## STAFF MEMORANDUM

RE: IN THE MATTER OF THE APPLICATION OF DRAKE CEMENT, LLC TO ESTABLISH A NEW RAILROAD CROSSING ON YAVAPAI COUNTY ROAD 71 NEAR DRAKE, YAVAPAI COUNTY, ARIZONA, USDOT NO. 933-885-T.

DOCKET NO. RR-20736A-10-0140

Figure 8B-3. Crossbuck Assembly with a YIELD or STOP Sign on a Separate Sign Support (Sheet 1 of 2)

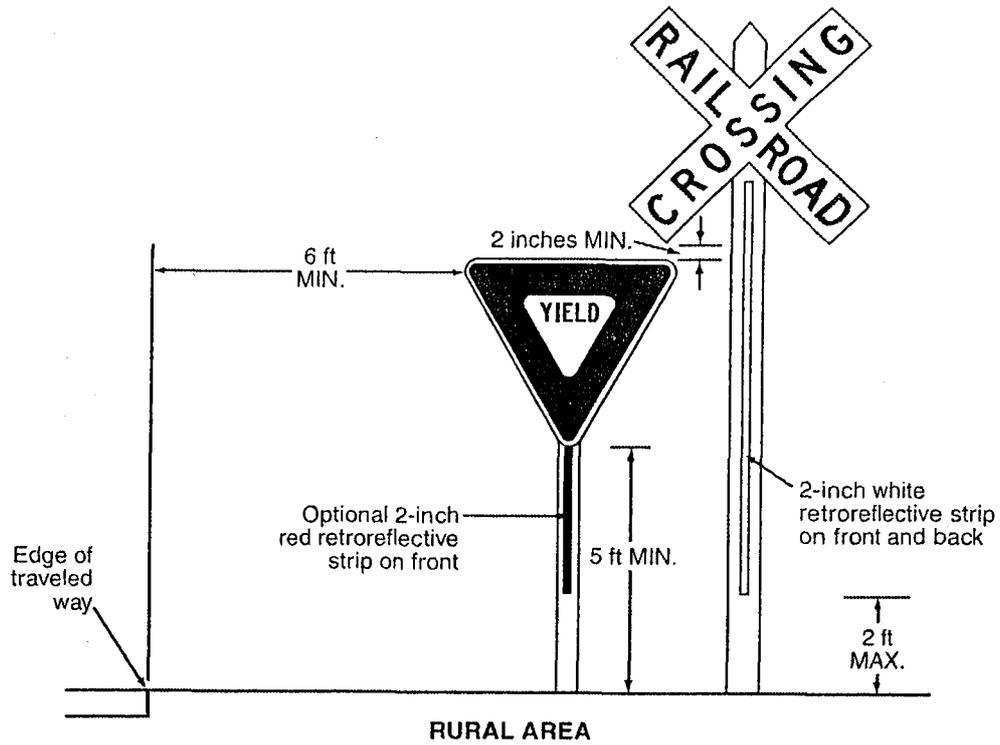
- railroad cross bucks along with Yield signs posted for both directions of travel at the crossing per the Manual on Uniform Traffic Control Devices (“MUTCD”) (see **Exhibit C**)
- advanced railroad crossing warning signs, per MUTCD posted on the roadway in both directions
- skewed angle warning signs per MUTCD posted on the roadway in both directions indicating the skewed angle in which the tracks will cross the roadway
- asphalt paving on the east and west approaches to the proposed new crossing that will include pavement markings indicating a railroad crossing per MUTCD
- two flagman, one for each direction of travel stationed at the crossing during travel through the crossing
- posting of the USDOT inventory number at the crossing

RR ENTRANCE GATE

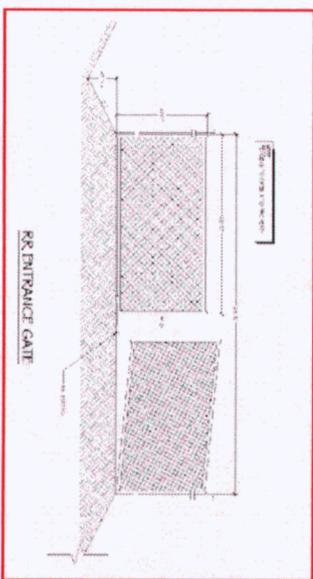
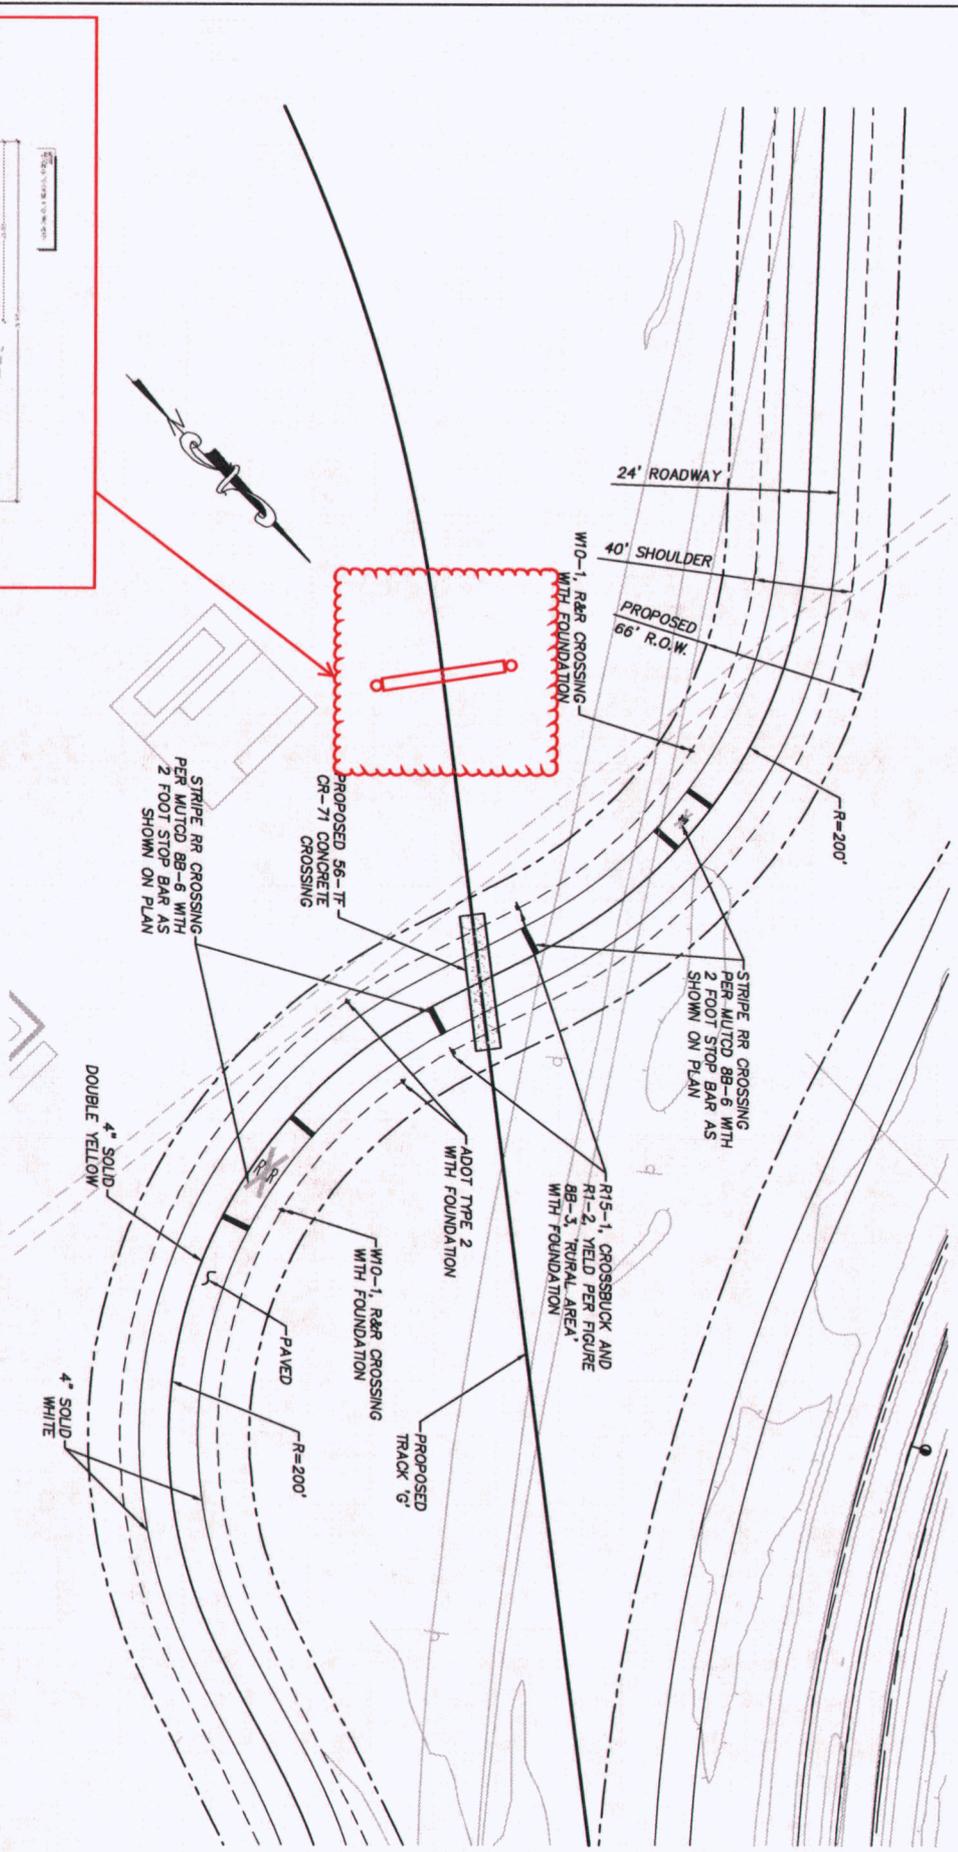
In addition, a gate will be constructed just off the right-of-way of CR71 on the Company's site, situated perpendicular to the rail spur as it enters the cement plant site. The gate will be 24 feet wide and 6 feet high and when closed and locked will block rail access into and out of the plant (see **Exhibit D**).
